November 2, 2020

RE: **Lot 2 Block 1 Volcano Cliffs Unit 22 SAD 228**
8001 Alto Rey Ct. NW
Grading and Drainage Plan
Engineers Stamp Date 10/29/2020 (D10D003N1)

GRADING AND DRAINAGE PLAN

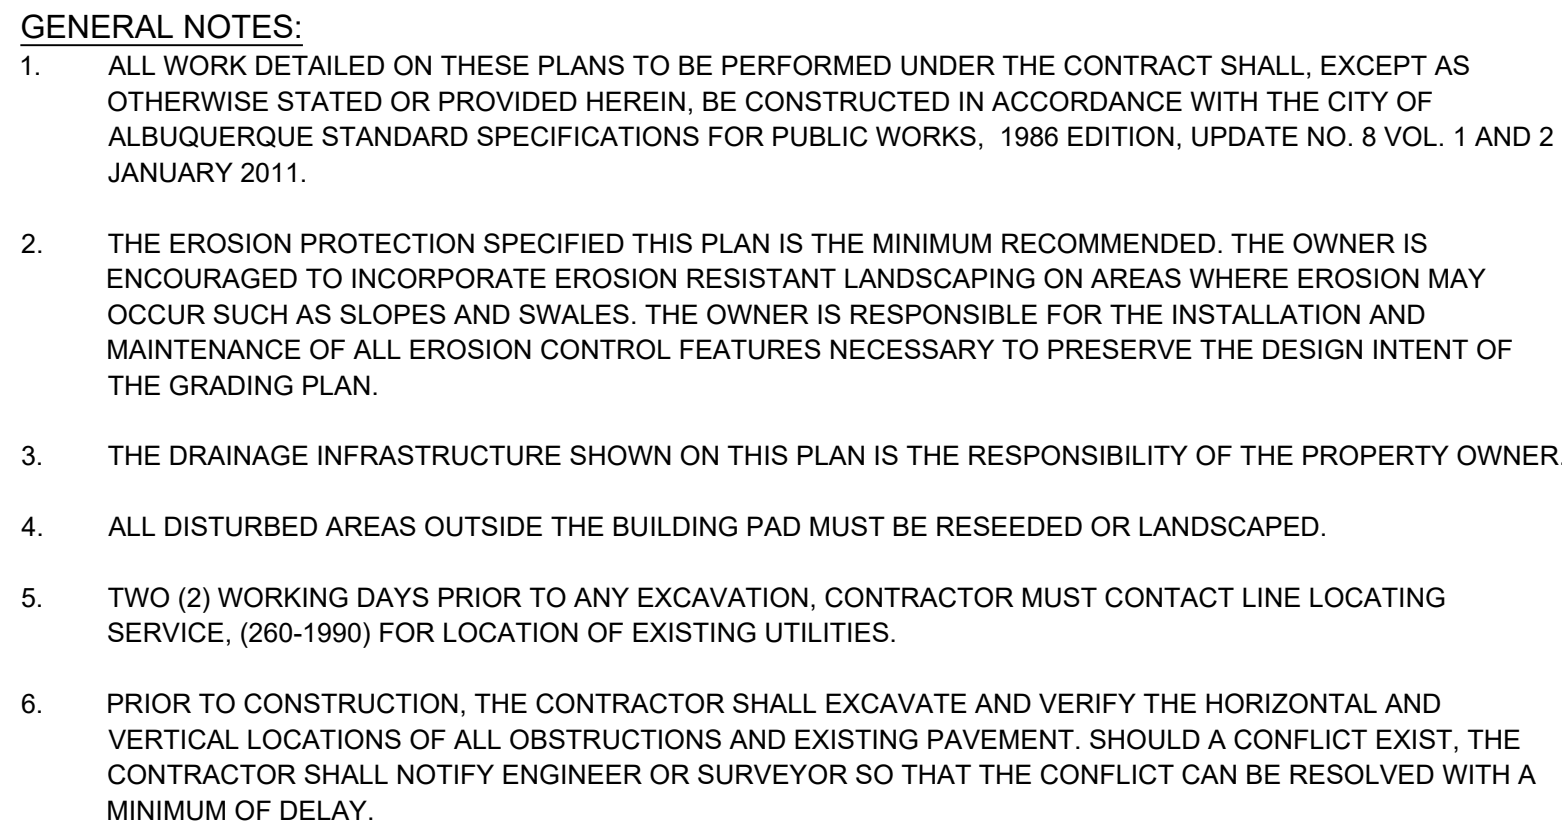
Based upon the information provided in your submittal received 10/30/2020, this plan is approved for Grading Permit.

Prior to Building permit approval a Pad Certification will be required, provided by the Engineer or a registered Land Surveyor.

Reiterate to the Owner/Contractor that a separate permit for a garden/retaining wall must be obtained with the approved G&D plan and Pad Certification. **Also, if a swimming pool is to be placed the grading and drainage plan will change and will need to be resubmitted.**

Prior to Certificate of Occupancy release, Engineer Certification per the DPM checklist will be required.
